Transport, Heritage and Planning Committee

Post Exhibition – Draft Sydney Development Control Plan 2012 – Darlinghurst Road, Potts Point

**Draft Sydney Development Control Plan
2012 – Darlinghurst Road, Potts Point**

Figure 3: 3m setback above 18-20 Darlinghurst Road for height of 1 storey above top of street wall, built to street alignment above

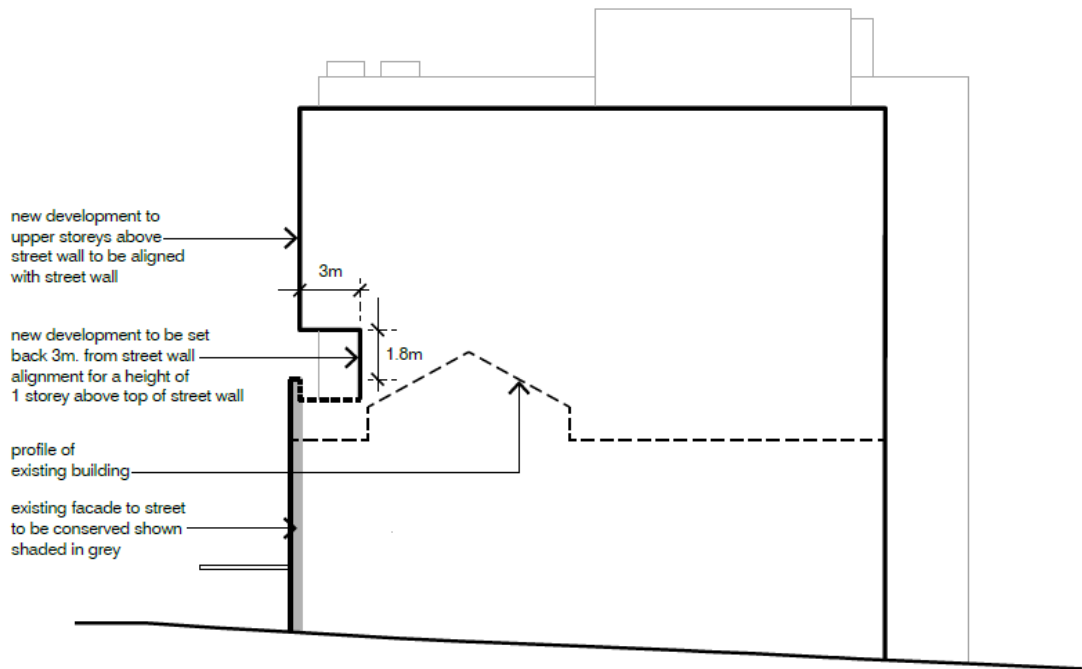
63. The requirement for a 3m setback requirement above the Lowestoft in Clause 6.2.12.8(2) relates only to the level immediately above the existing building. Development above can be built to street alignment as shown in Figure 4 in the DCP, which has been updated for clarity and is shown below (Figure 3). This is the minimal setback possible to differentiate between the existing building and new development above. No change to the control is recommended.

Figure 4: Revised built form and setbacks diagram. The diagram reflects changes to the rear setback control, which are based on solar access requirements.

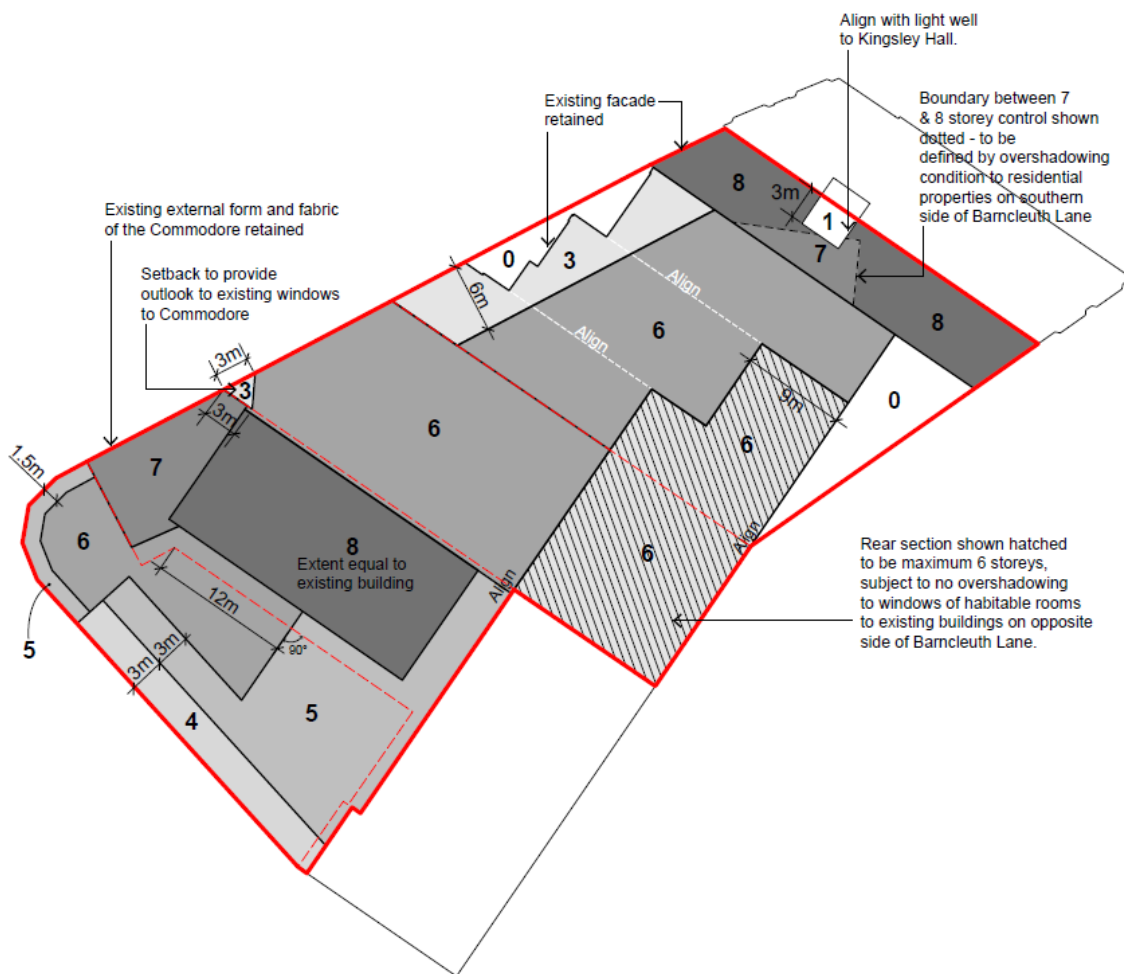
66. After further consideration, and in response to concerns raised by landowners, changes to Clause 6.2.12.9 Built form and setbacks are recommended to explain the intent of the setbacks and the control has been modified so that side and rear setbacks are determined by preservation of solar access to properties on Roslyn Street and Barncleuth Lane. Figure 6a is also updated to reflect these changes.

67. The provisions contain a 6m setback above the Bourbon façade which runs parallel to the boundary. The 6m requirement varies from heritage advice and has been reduced to provide greater flexibility for the built form and architecture and enable residential development to comply with amenity requirements whilst still respecting the heritage significant fabric below. The side setbacks to the Empire allow the reinterpretation of the original building form and protect solar access to properties on Roslyn Street. No changes are proposed to the Bourbon and Empire setbacks.

68. Minor changes have been made to Clause 6.2.12.9 Built form and setbacks and Figure 6a. The changes allow development to vary the setbacks prescribed by the control when development minimises overshadowing to buildings on the south side of Barncleuth Lane and is consistent with the requirements of the ADG, as shown below at Figure 4.

Figure 6a: Building heights and setbacks plan (maximum heights noted in storeys)

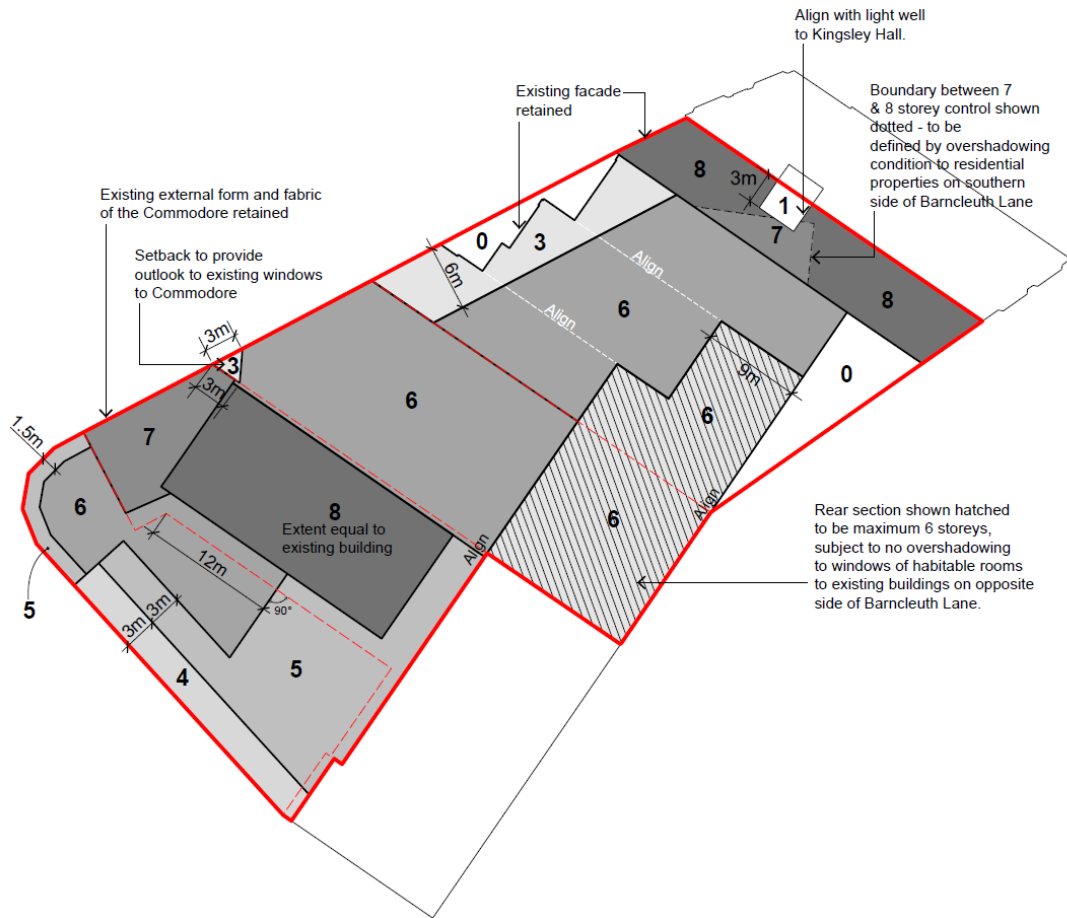
<p><u>Building envelope for 18-32A Darlinghurst Rd</u> (issue raised in 1 individual submission)</p> <p>The site specific building envelopes be revisited and explored further to address issues such as monotony in height and bulk, and consideration for more height to the Empire site as a bookend to Kingsley Hall.</p> <p>The precise dimensioned plan for storeys and setbacks (Fig. 6a) is overly prescriptive. Performance based controls could be established relating to sensitive streetscape design and acknowledgement of heritage items, shadowing impacts, appropriate design of the corner building to Darlinghurst Rd and Roslyn Street, and best fit for good apartment design and ADG compliance.</p>	<p>The existing building height of the Empire cannot be amended via the DCP. The building envelope and setbacks for 18-32A Darlinghurst Road can be modified subject to compliance with overshadowing and amenity requirements as per the ADG. This has been clarified in the controls and in <i>Figure 6a</i>.</p> <p>The envelope has been developed with the City's Design Advisory Panel. The parallel-to-boundary setback for development above the Bourbon respects the heritage significance of the facade, whilst the shadow line above the Lowestoft allows the original built form to be legible and distinct from the future addition. The setbacks to the Empire allow for the reinterpretation of the building and protect solar access to properties on Roslyn Street.</p> <p>As noted above, controls contained in <i>Clause 6.2.12.9 – Built form and setbacks</i> have been revised and <i>Figure 6a</i> has been amended accordingly. See discussion in report.</p>

- (1) Development must not exceed the maximum building envelopes described by 'Figure 6a: Building heights and setbacks plan'.
- (2) The envelopes described by Figure 6a is the maximum permissible extent of the built form and the final building designs must be appropriately massed within the envelope.

- (3) Setbacks above the street wall height should be provided in accordance with 'Figure 6a: Building heights and setbacks plan.'

(4) The objectives of the setbacks described in Figure 6a: Building heights and setbacks plan are to ensure development:
